**Waterbury Hospital Health Center,  
64 Robbins Street  
Waterbury CT 06721**

REFERENCE: License # 06-02406-01 Amendment

01AmdRe-commissionRm0305

## Cardiology Facility with This Amendment

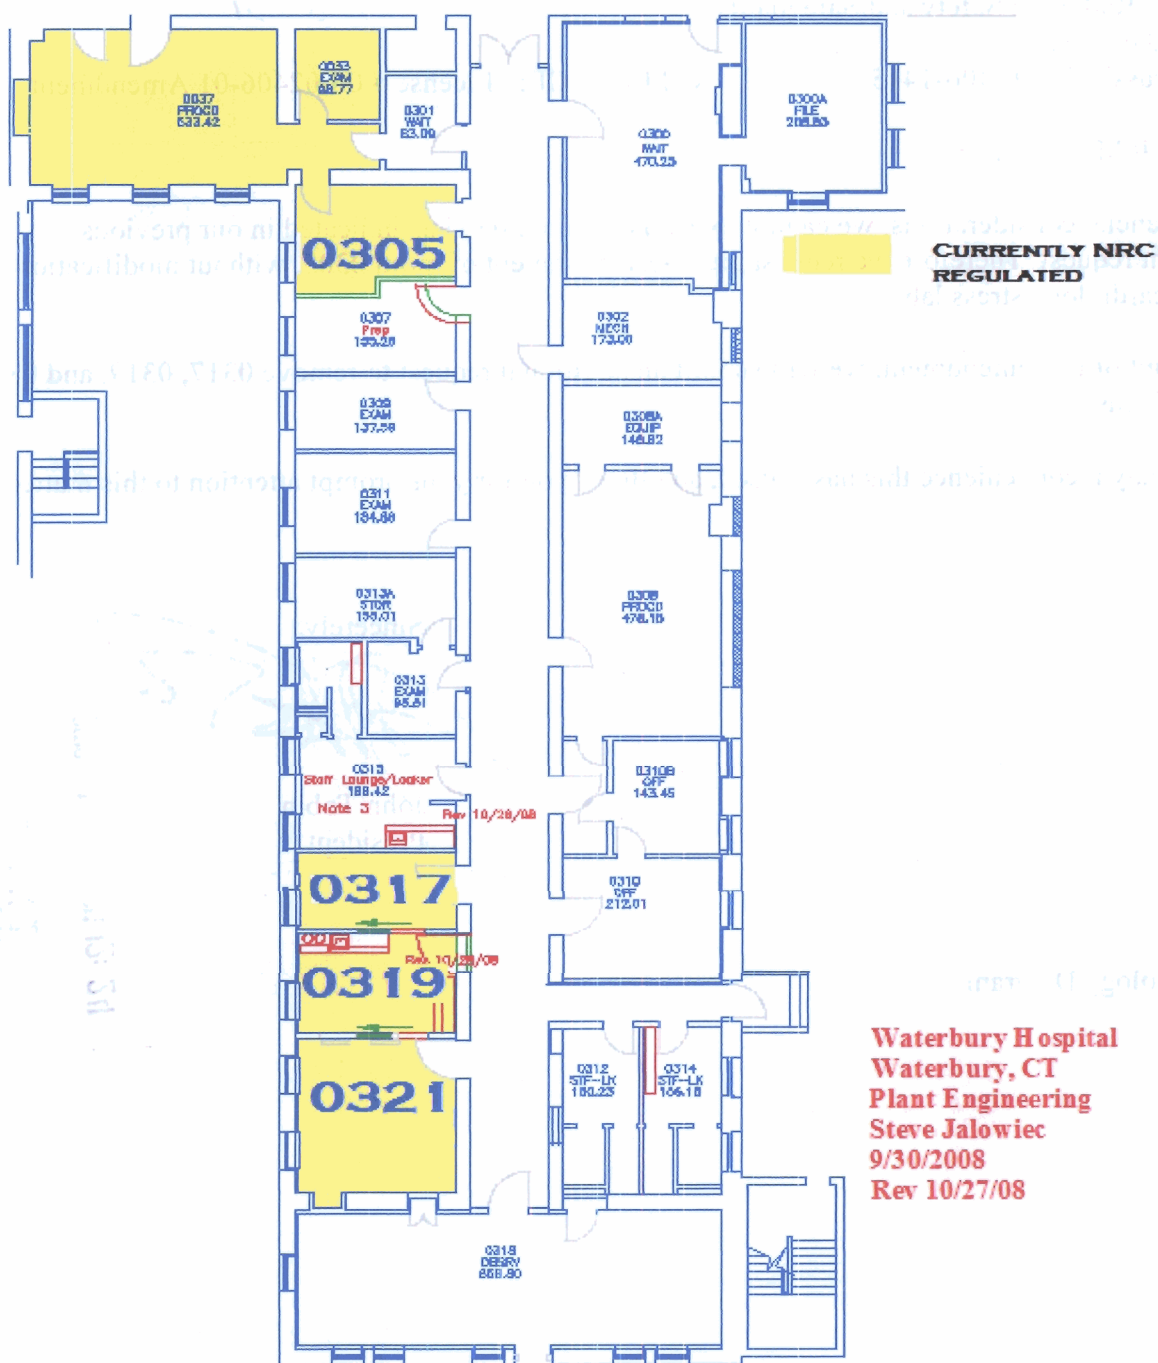
A. Original Room 0305 to be re-commissioned as the nuclear cardiology stress lab as shown.
